State Significant Development Response to Submissions

31 Wheat Road, Sydney

Redevelopment of IMAX Building

Submitted to Department of Planning and Environment
On Behalf of Grocon Pty Ltd

Figure 1 – Original proposal. Note the proximity of the façade to the elevated roadway (circled) and the location of the escalators within the view line (arrow)

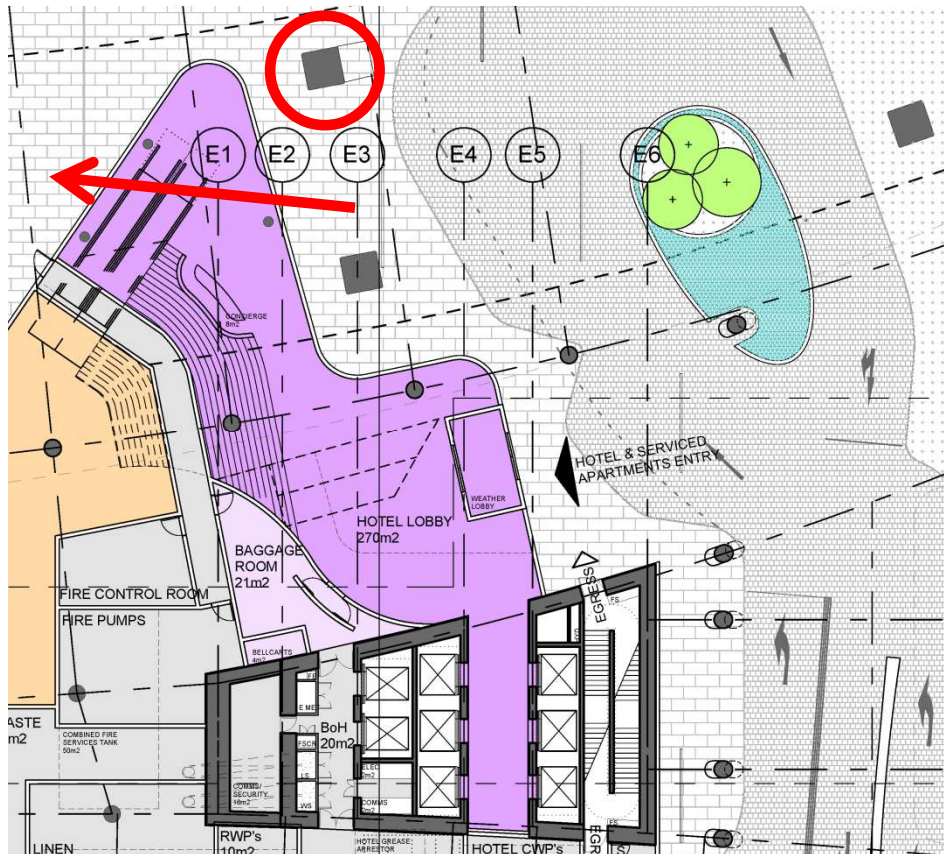
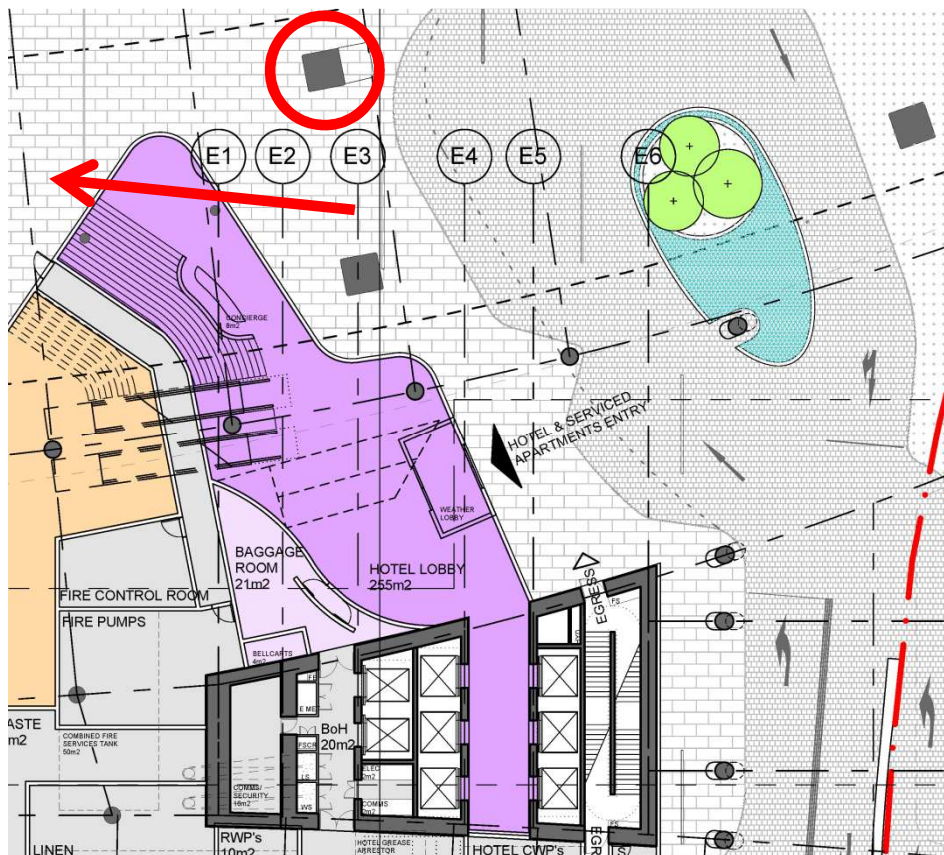
The layout and design of the hotel lobby and port cochere have been refined to enhance the public domain, maintain sight lines and ensure there is appropriate pedestrian accessibility. The key change is the refinement of the glazing line at that northern end of the lobby, and the relocation of the internal escalator (refer to **Figures 1 and 2** below). These changes ensure that appropriate spaces and views for pedestrians are provided, whilst at the same time the proposed building relates appropriately to the existing built form context.

Figure 2 – Refined proposal. Note the increased separation to the elevated roadway structure (circled) and the relocation of the escalators to allow for views through the façade
